QUALITY ASSURANCE -- NON-CONFORMANCE REPORT

Location: Changxing Island, Shanghai, P.R. China**Report No:** NCR-000703**Prime Contractor:** American Bridge/Fluor Enterprises, a JV**Date:** 25-Mar-2010**Submitting Contractor:** Zhenhua Port Machinery Company, Ltd (ZPMC), Changxing Island**NCR #:** ZPMC-0670**Type of problem:**

Reference Description: Missed UT indication by QC on Segment 9BW BP to BP CJP Joint**Description of Non-Conformance:**

Job Name: SAS Superstructure

WELD NUMBER: SEG051A-003

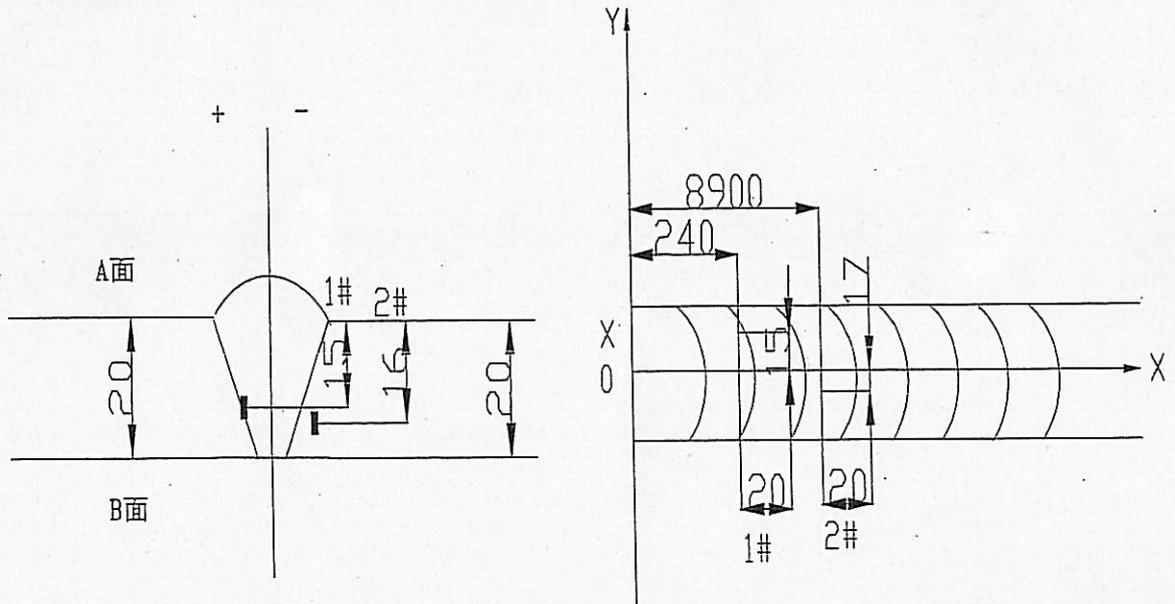
Rejected indication found by ultrasonic inspection is less than the maximum allowance aggregate length.

(UT探伤发现的缺陷总长度小于最大允许长度。) SEG051A-003

1. 焊道未及时处理干净。
1. Did not clear the weld pass completely in time.

1. 从缺陷距离端面较近一侧 ($D \leq 0.65T$, D 为缺陷深度, T 为板厚) 采用碳刨或打磨的方法去除焊缝缺陷;
 2. 参照返修焊接工艺规程 (WPS) 准备正确的接头型式, 预热和焊接;
 3. 焊前对修补区域进行VT检测保证缺陷完全被消除;
 4. 将修补区域打磨到与母材或邻近焊缝平齐;
 5. 对焊缝进行UT检测, 检测范围为返修区域以及其两端各延长50mm.
-
1. Gouge or grind from nearer side from metal edge ($D \leq 0.65T$, "D" is depth of defects, "T" is thickness of metal) to remove all defects;
 2. Follow repair WPS for joint preparation, preheat, and weld deposit;
 3. Verify with VT no defects remain in the weld joint prior to welding;
 4. Grind the repaired area flush with base metal or the adjacent weld;
 5. Perform UT inspection to the weld along with 50mm on each end of the repair area;
